**GE Hitachi Nuclear Energy**

MFN 08-968

**Subject: Response to Portion of NRC RAI Letter No. 185 Related to ESBWR Design Certification Application – DCD Tier 2 Section 3.6 – Protection Against Dynamic Effects Associated With The Postulated Rupture Of Piping; RAI Numbers 3.6-6 S02, 3.6-11 S01, 3.6-12 S01, 3.6-13 S01, 3.6-14 S01, 3.6-15 S01, 3.6-16 S01, 3.6-17 S01**

**DCD Tier 2, Section 3.6 - Protection Against Dynamic Effects  
Associated With The Postulated Rupture Of Piping**

FIGURE 2.7 Maximum response of one-degree elastic systems (undamped) subjected to rectangular and triangular load pulses having zero rise time. (U.S. Army Corps of Engineers.<sup>10</sup>)

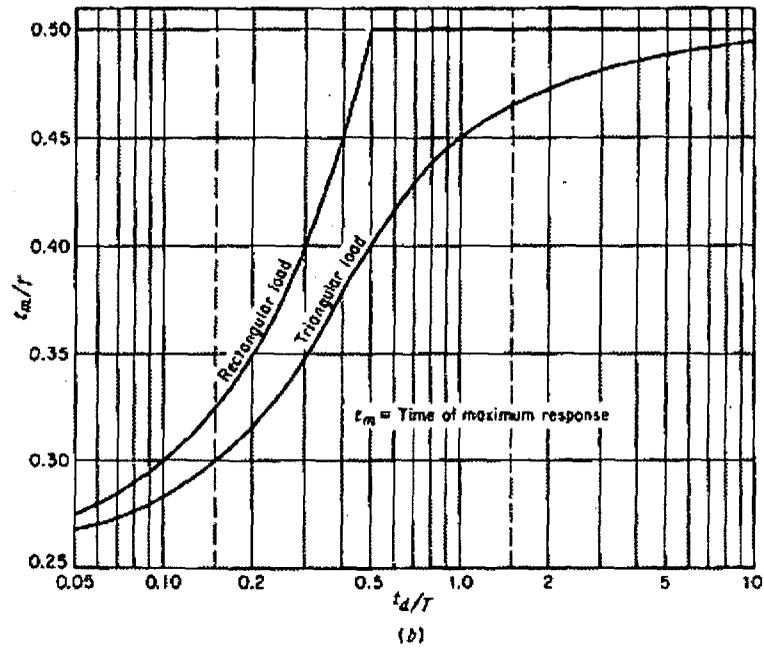
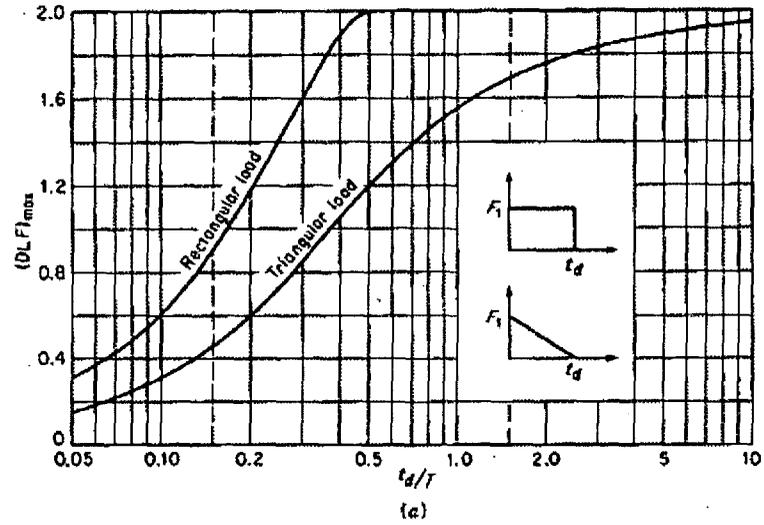
*(c) Clarify whether dynamic jet loads are to be considered, and if so, using what methods. Also, should the dynamic loading include strong excitation at discrete frequencies corresponding to resonance frequencies of the SSC impinged upon, provide the basis for assuming a static analysis with a dynamic load factor of two is conservative.*

As stated in ANS 58.2 section 7.3, an equivalent static analysis, a dynamic load factor (DLF) of 2 is conservative. This is because ANS 58.2 assumes the jet impingement force to have 0.001 second rise time and reaches constant value. The force has no discrete frequencies corresponding to resonance frequencies of the SSC being impinged upon. Figure a) below shows the "Maximum response of one-degree elastic system (undamped) subjected to rectangular and triangular pulse having zero rise time" from "Introduction to structural dynamic" by John M Biggs. The maximum DLF is 2.0. If the rise time is considered, the DLF will be less than 2.0. For multiple degree system subject to jet impingement load, the maximum dynamic load factor (DLF) of 2 is also applicable.
